1987 - 1991 Corvette: Service Bulletin: 4L60 Low & Reverse Clutch New Plate Available

Subject: 4L60 LOW & REVERSE CLUTCH NEW WAVE PLATE IS AVAILABLE

Bulletin Number: 91-186-7A - (01/29/1991)

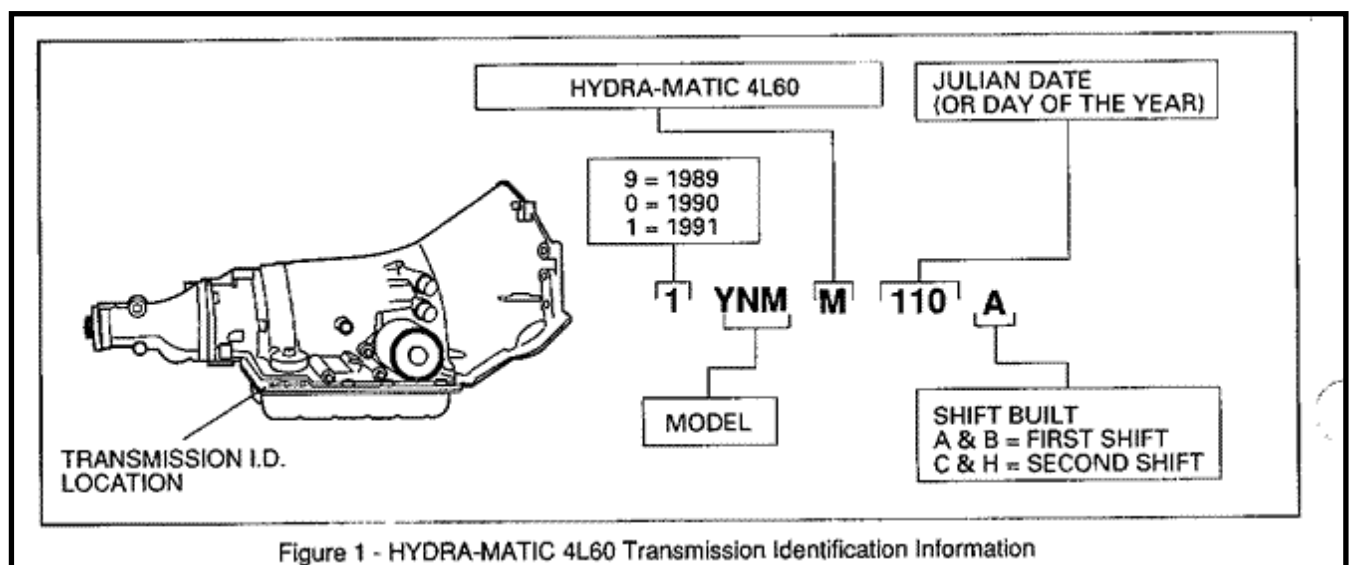
DATE OF PRODUCTION CHANGE: (Figure 1)

----- Beginning March 28, 1990 (Julian Date 087), all HYDRA-MATIC 4L60 transmissions were built using the new low and reverse clutch wave plate.

Figure 2 - Lo And Reverse Clutch Waved Plate

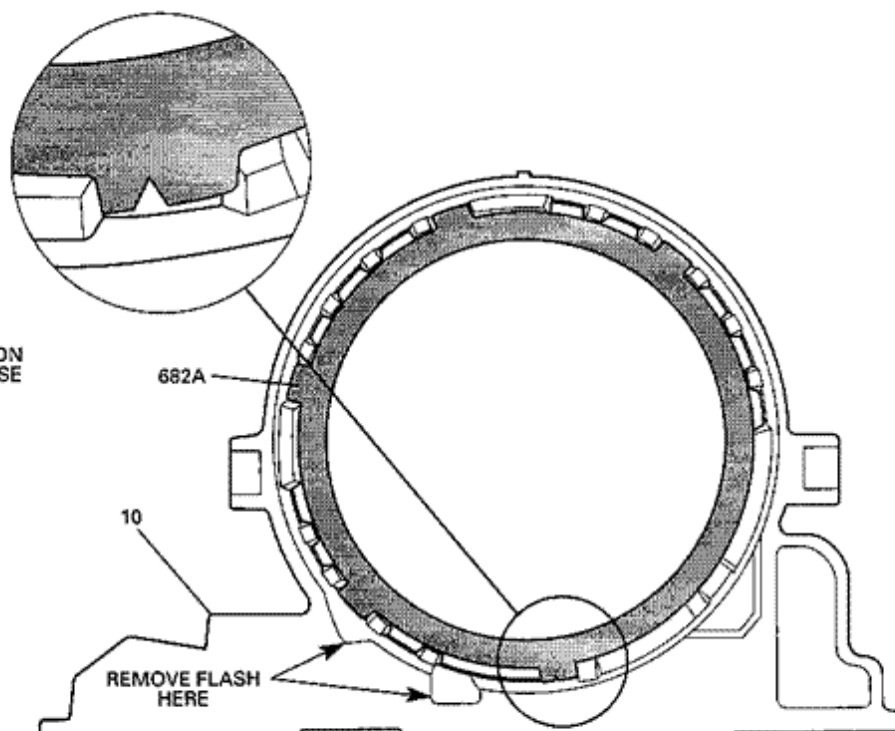
SERVICE INFORMATION: (Figure 2) ----- Low and Reverse Clutch failure can be caused by case casting flash interfering with clutch plate travel. A new wave plate is now available which will alleviate this condition. This new plate can be used to service any Hydra-matic 4L60 transmission produced after February 9, 1987 (Julian Date 040).

When installing the new wave plate, check for any case flash that may be present in the low and reverse grooves, and use a metal file to remove. See Figure 2 for case location information.

Plate - Low and Reverse (wave) 8676362
